## Executive Director's Recommendation

<b>PROJECT</b> <b>South Mall Campus Master Plan</b> National Mall, between 7 <sup>th</sup> Street, SW, Jefferson Drive, SW, 12 <sup>th</sup> Street, SW, and Independence Avenue, SW Washington, DC	<b>NCPC FILE NUMBER</b> 7630
<b>SUBMITTED BY</b> Smithsonian Institution	<b>NCPC MAP FILE NUMBER</b> 1.41(05.00)44050
<b>REVIEW AUTHORITY</b> Approval of Master Plans for use by the Commission per 40 U.S.C. § 8722(a) and (b)(1)	<b>APPLICANT'S REQUEST</b> Approval of comments on concept master plan and draft EIS alternatives
	<b>PROPOSED ACTION</b> Approve comments on concept master plan and draft EIS alternatives
	<b>ACTION ITEM TYPE</b> Staff Presentation

# NCPC File #7630

Comments on Concept Master Plan and  
Draft Environmental Impact Statement  
Alternatives

## EXCAVATION COMPARISON

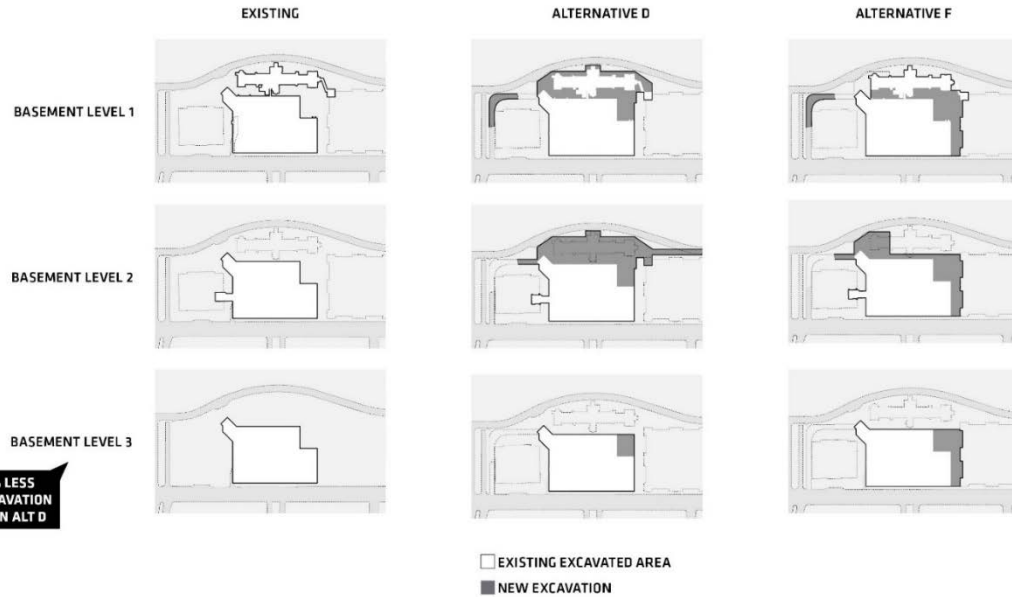
**Notes** that Alternative D includes the greatest amount of excavation beneath the Castle.

**Finds** the Alternative B and F minimize the amount of sub-basement excavation by accommodating the program elsewhere in the campus.

## PAVILION RELOCATION

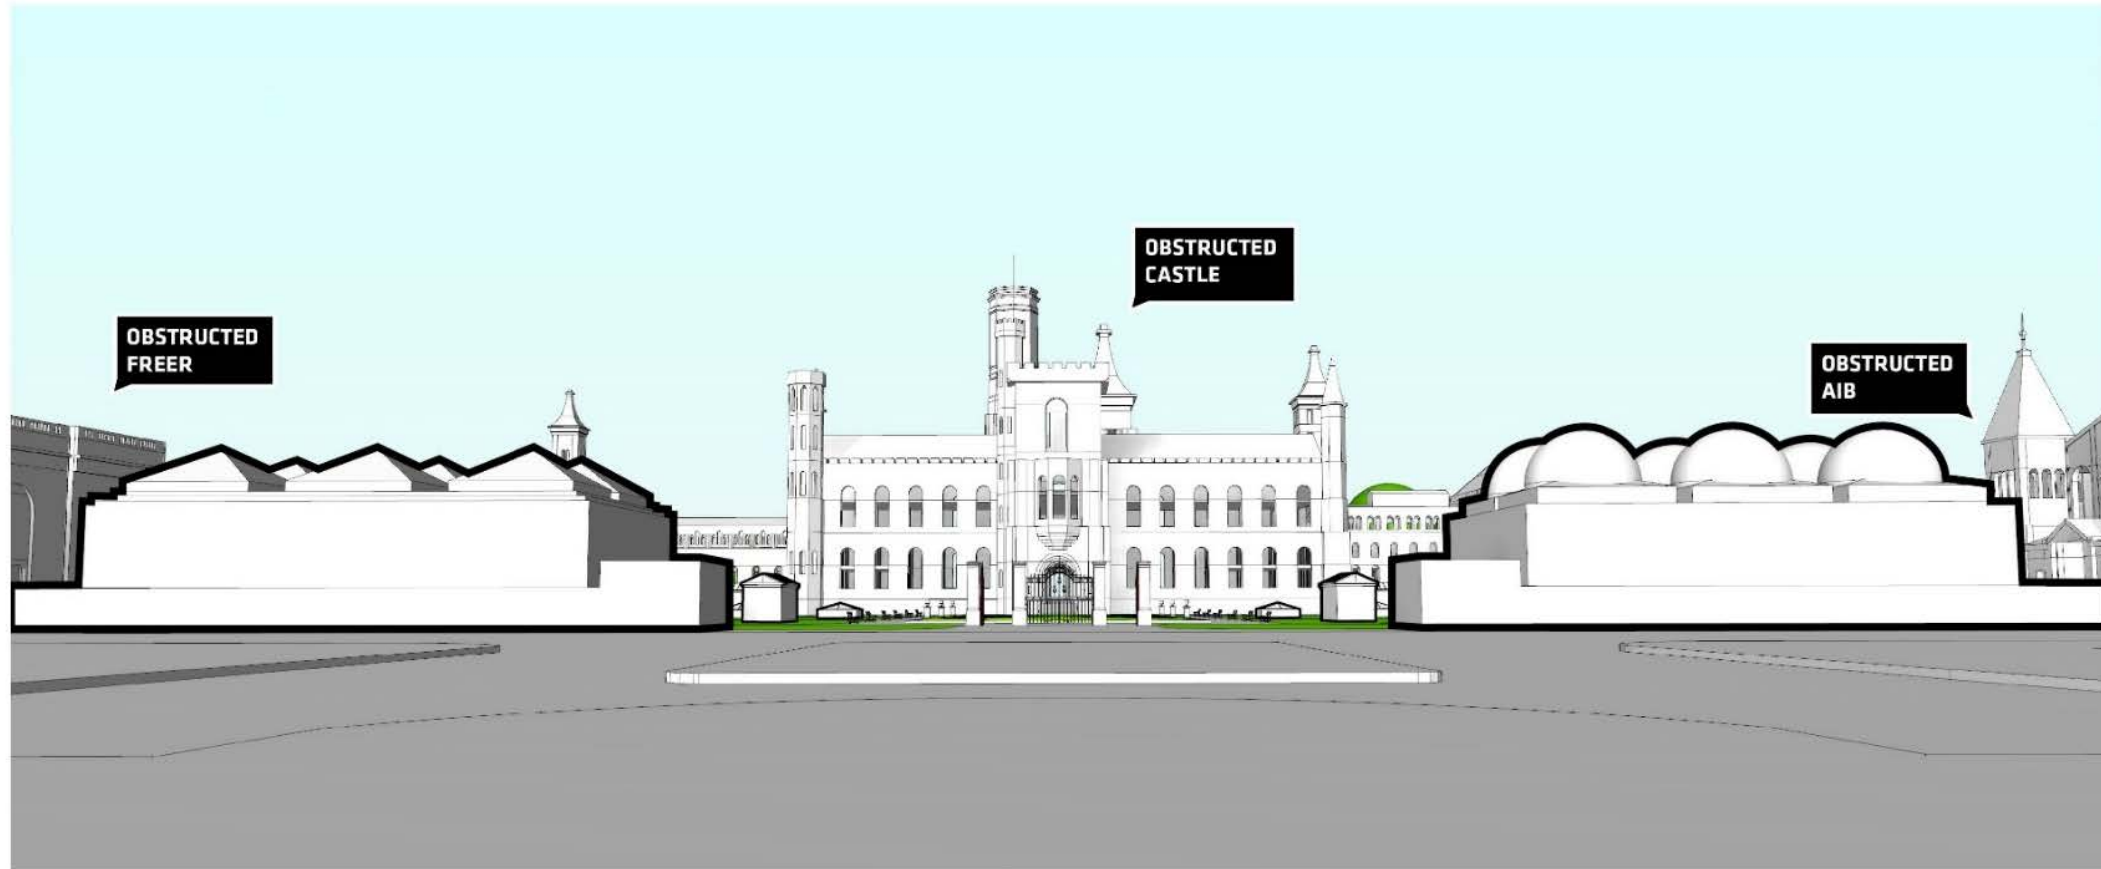
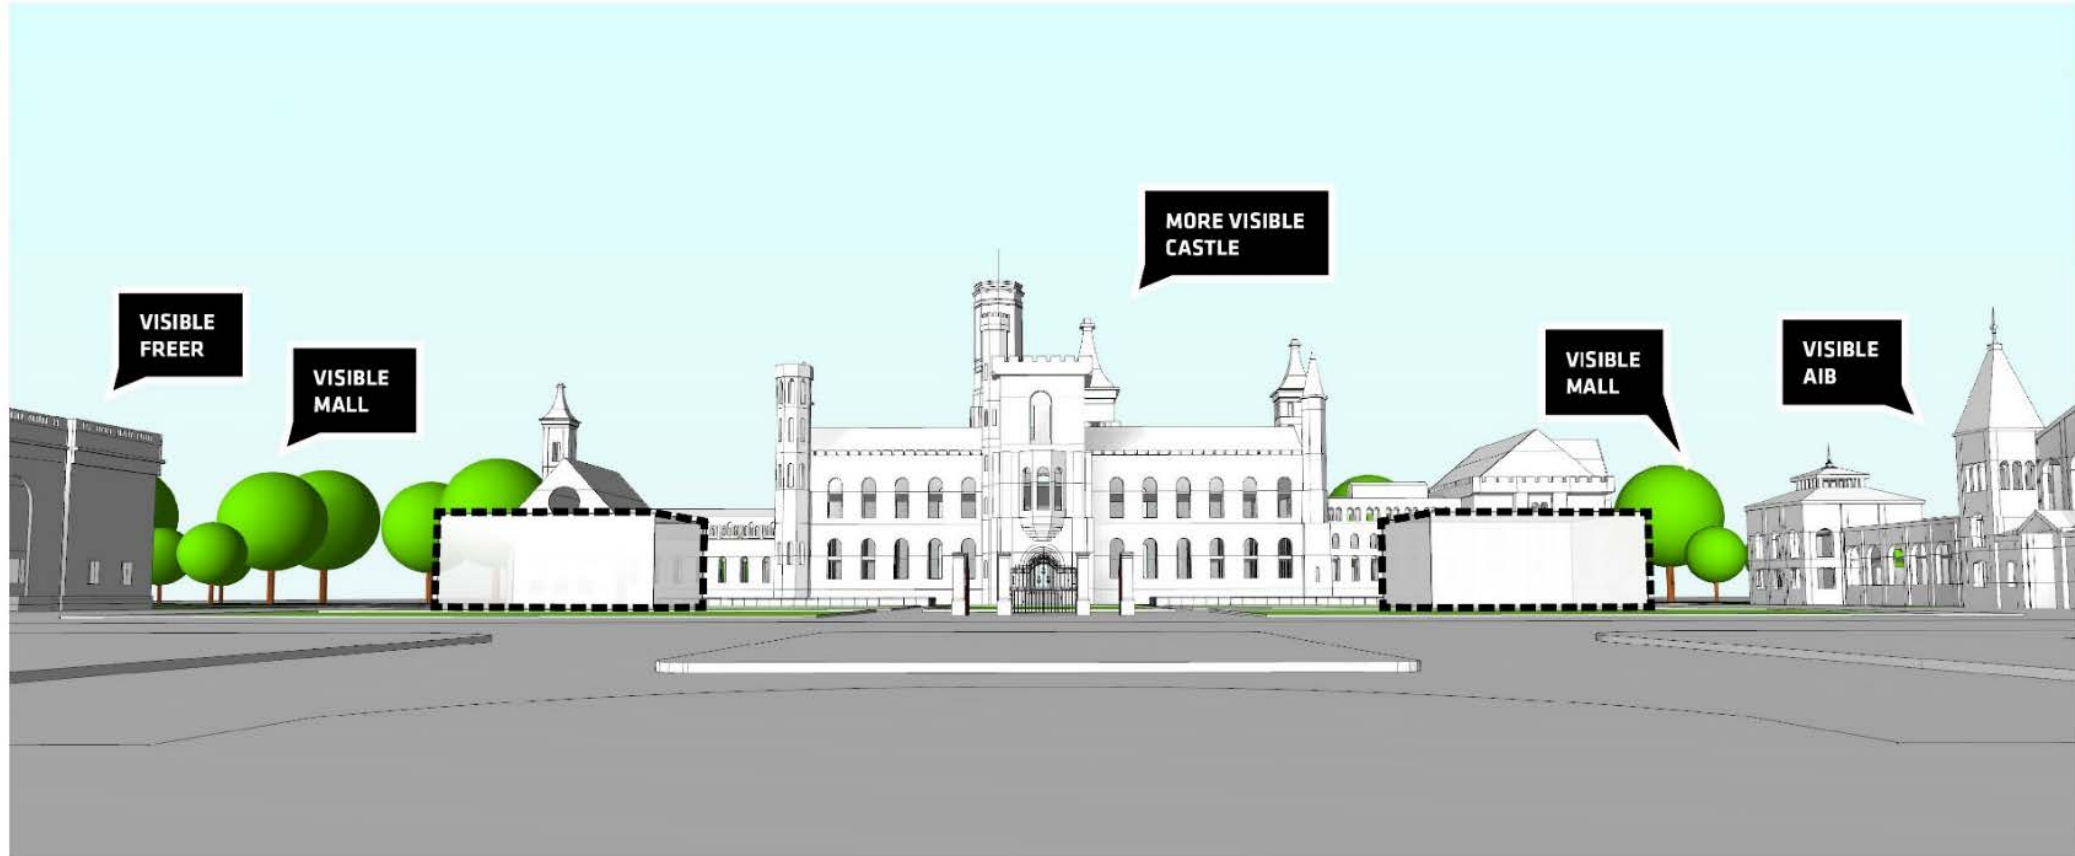
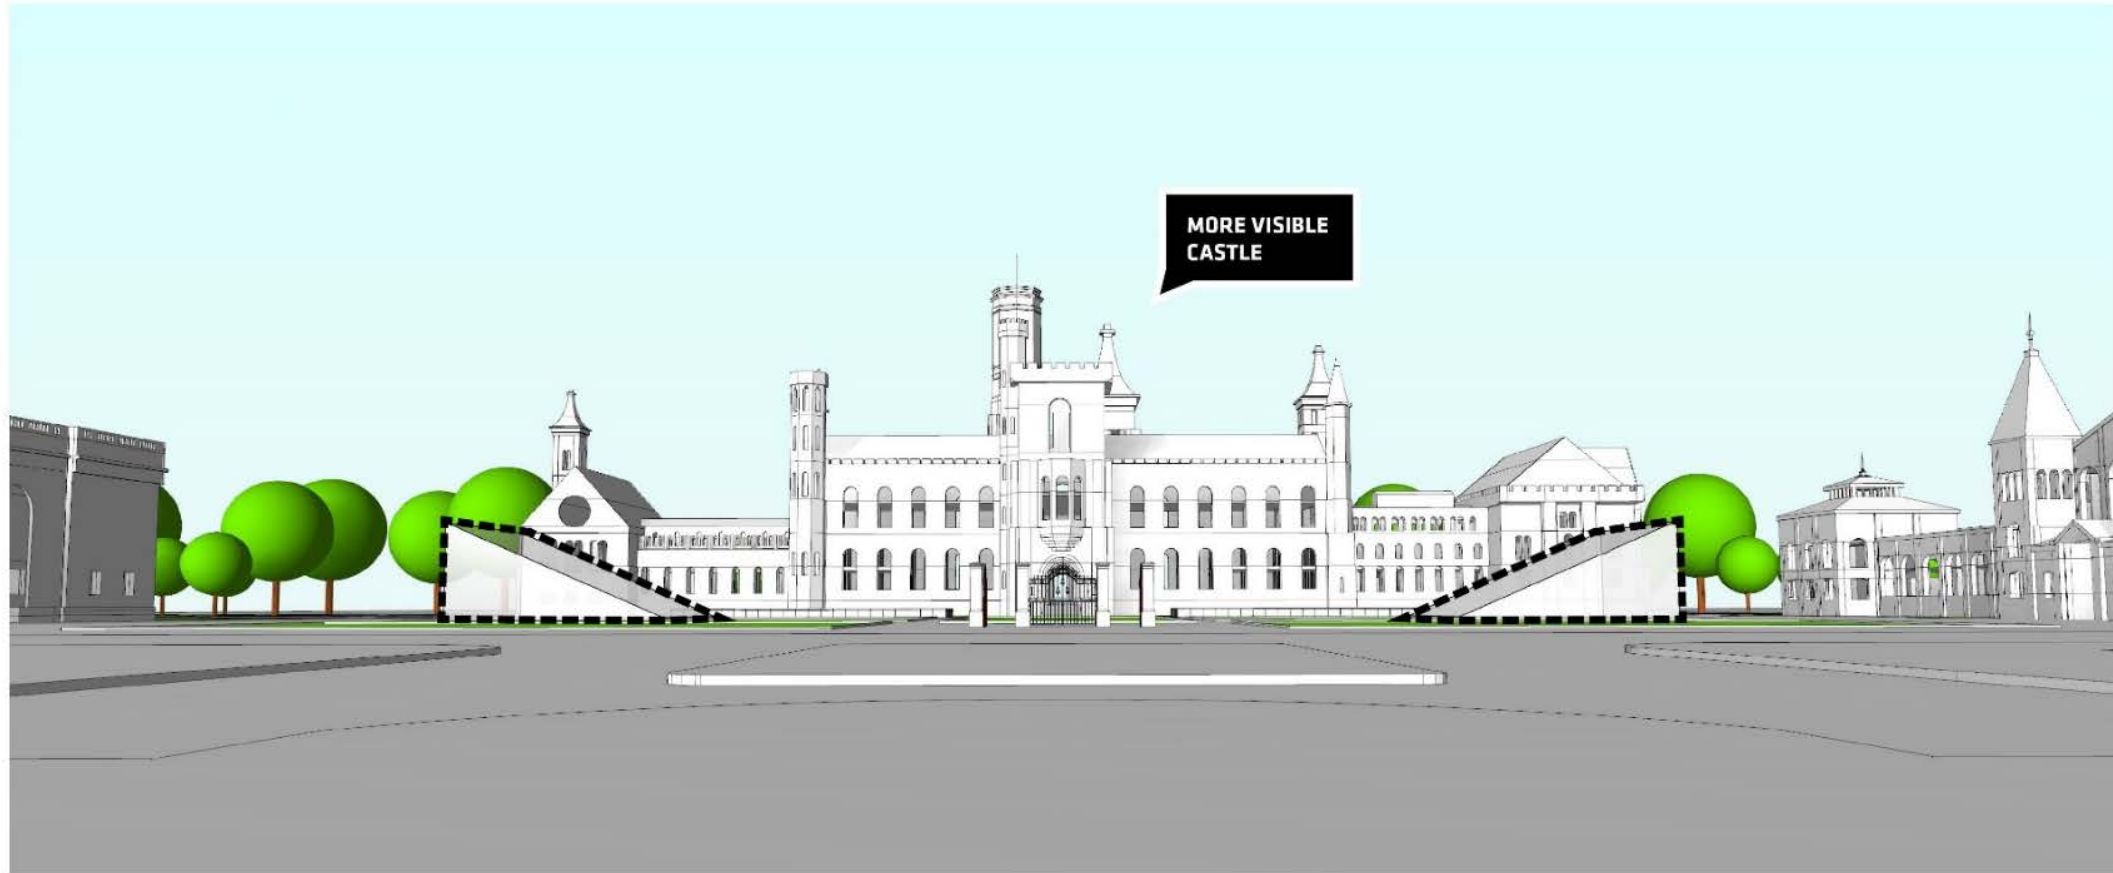
**Finds** the current location of the pavilions affects the configuration and functionality of the below-grade Quadrangle interior spaces, as well as views of the Castle from Independence Avenue and 10<sup>th</sup> Street, SW to the south.

**Finds** that Alternative D and F replace the existing pavilions with smaller pavilions closer to the Castle, allowing for improvements to the functionality of the Quadrangle interior spaces.

**Finds** that smaller, relocated pavilions could improve views of the Castle and the National Mall from the south, and over time guide visitors from the Southwest Quadrant of the City, including the SW Ecodistrict, the Wharf and Waterfront, which are connected along 10th Street, SW, and are undergoing tremendous growth.

HIRSHHORN WEST WALL

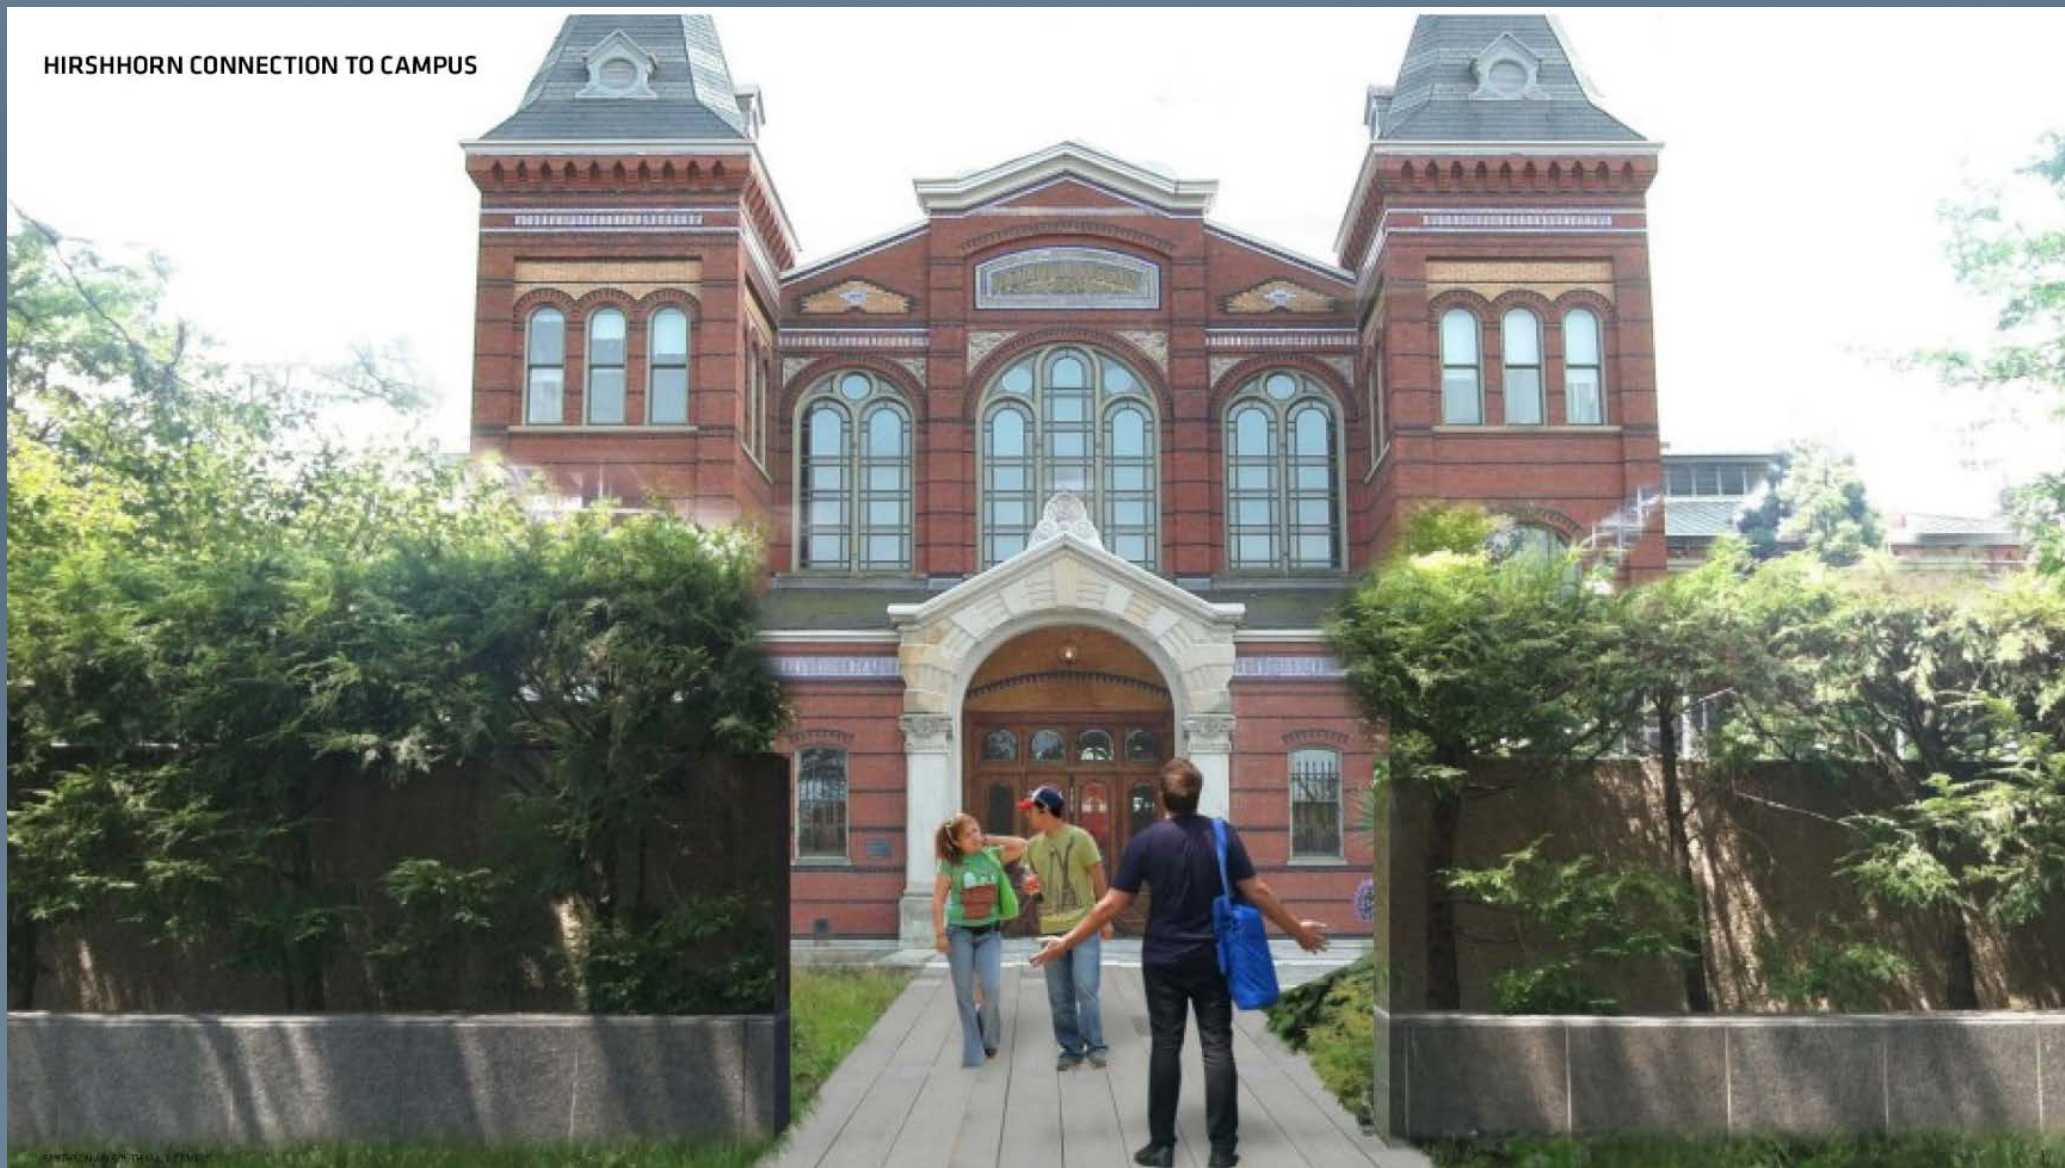
**Finds** that a modest opening in the western site wall would facilitate pedestrian connections to AIB, while larger alterations of the wall will change the character of the Hirshhorn Museum site.
